AREAS OF MODIFICATION BETWEEN APPROVED DRAINAGE GRADING PLAN AND ACTUAL AS-BUILT

OSUNA OFFICE COMPLEX  
Albuquerque, NM

DRAINAGE AND GRADING PLAN

OSUNA OFFICE BUILDING  
6621 GULTON CT. NE  
ALBUQUERQUE, NM 87109

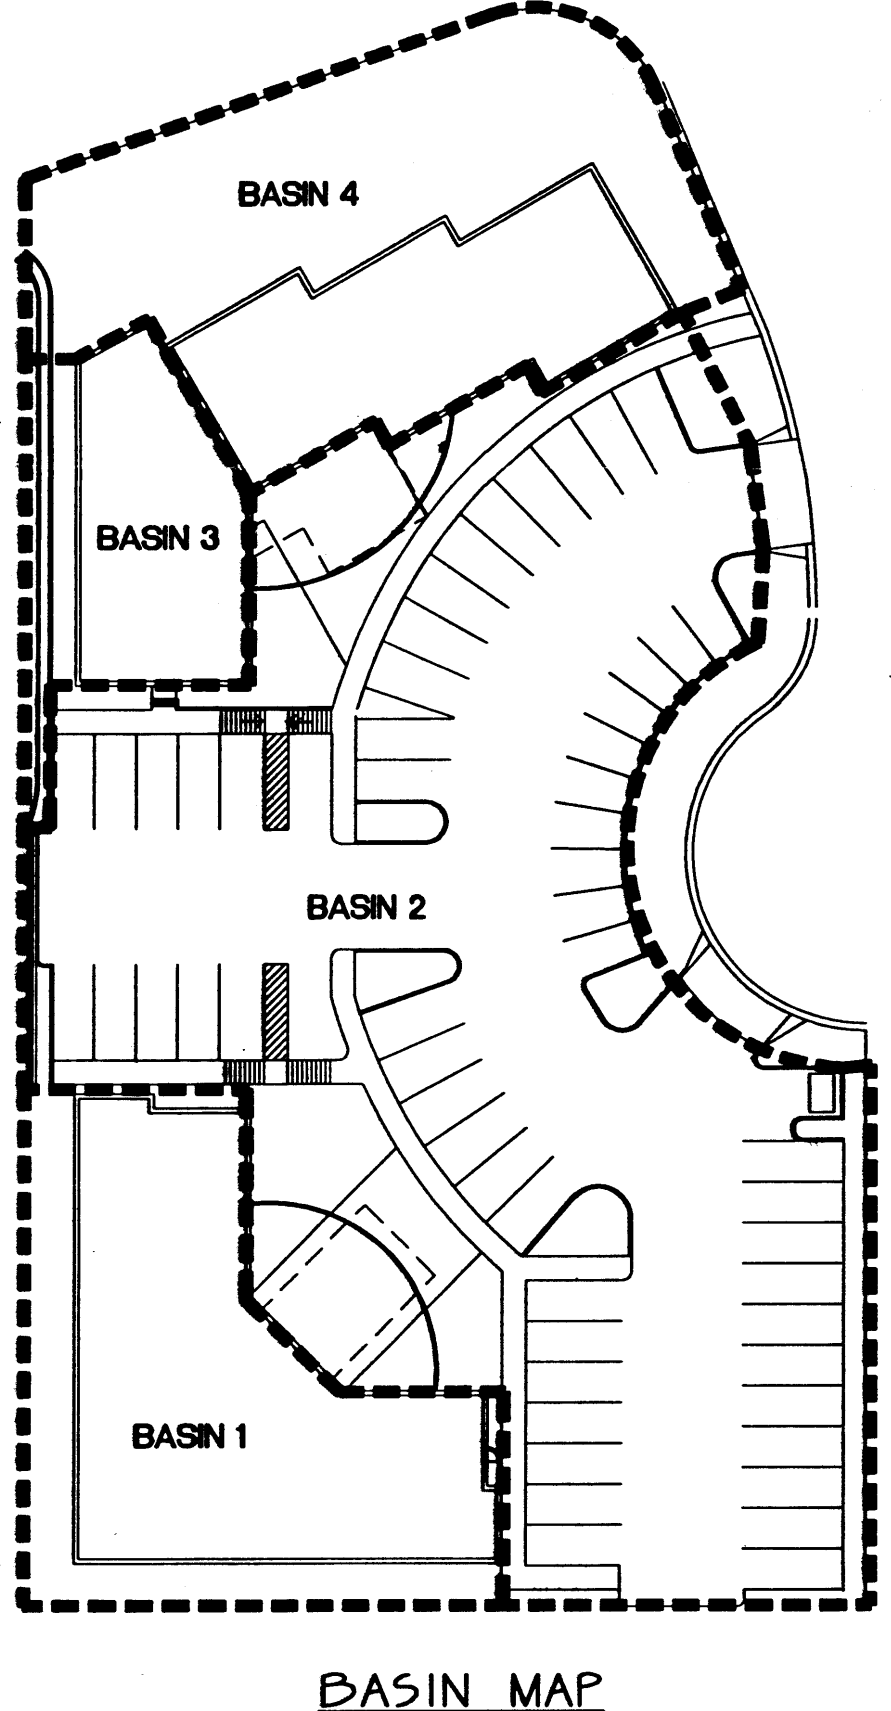
- 1. F.F. elevations / site plan elevations differ from approved plan. General drainage paths / calculations still apply - acceptable.
- 2. Concrete drainage swale extended to southwest corner - Acceptable. Facilitates drainage from south.
- 3. Grades this area are terraced using railroad retaining walls - Acceptable. Does not affect drainage.
- 4. Site plan feature not shown on original plan. Acceptable. Does not affect drainage.
- 5. Railroad retaining wall constructed along west property line to accommodate grade difference. Channel transition detail not constructed per plan. Acceptable. Does not affect drainage.

I, Christopher L. Weiss, P.E. hereby certify that the as-built information shown is in substantial compliance with the approved drainage / grading plan.  
Christopher L. Weiss, P.E. (N.M.P.E. #6653) Date 7.14.97  
As-Built Survey provided by Forstbauer Surveying Co.
